Improved Technical Specifications

Dresden Station

Volume 9:
Section 3.8

3.8 ELECTRICAL POWER SYSTEMS

Notes 1, 2, and 3 to SR 3.8.1.3

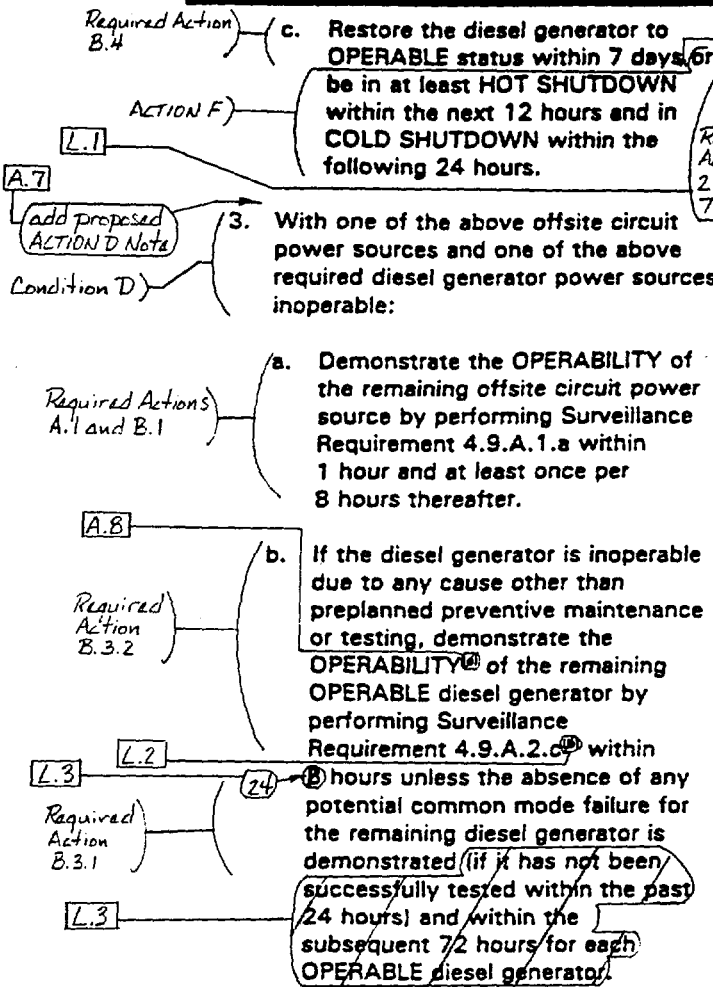
L.2 *d Momentary transients outside of the load range do not invalidate this test. Diesel generator loadings may include gradual loading as recommended by the manufacturer/vendor. This surveillance shall be conducted on only one diesel generator at a time.*

SR 3.8.1.20
Note

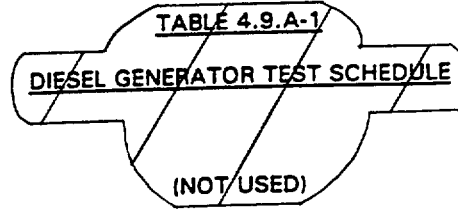
a All diesel generator starts may be preceded by an engine prelube period. ~~All diesel generator starts that require loading may be preceded by an engine prelube period and followed by a warmup period prior to loading.~~ Diesel generator loadings may include gradual loading as recommended by the manufacturer/vendor.

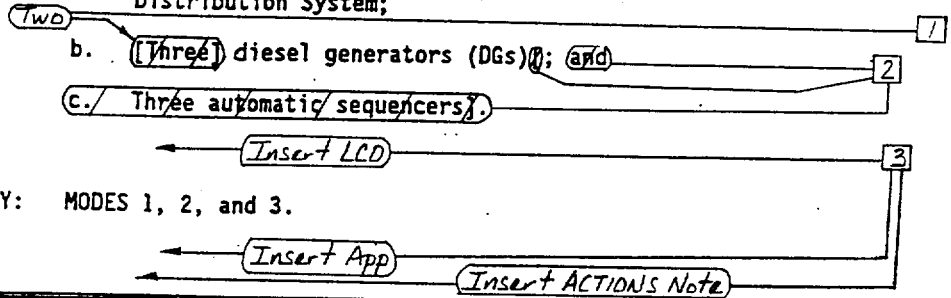
b. ~~Three~~ diesel generators (DGs); and

c. ~~Three automatic sequencers.~~
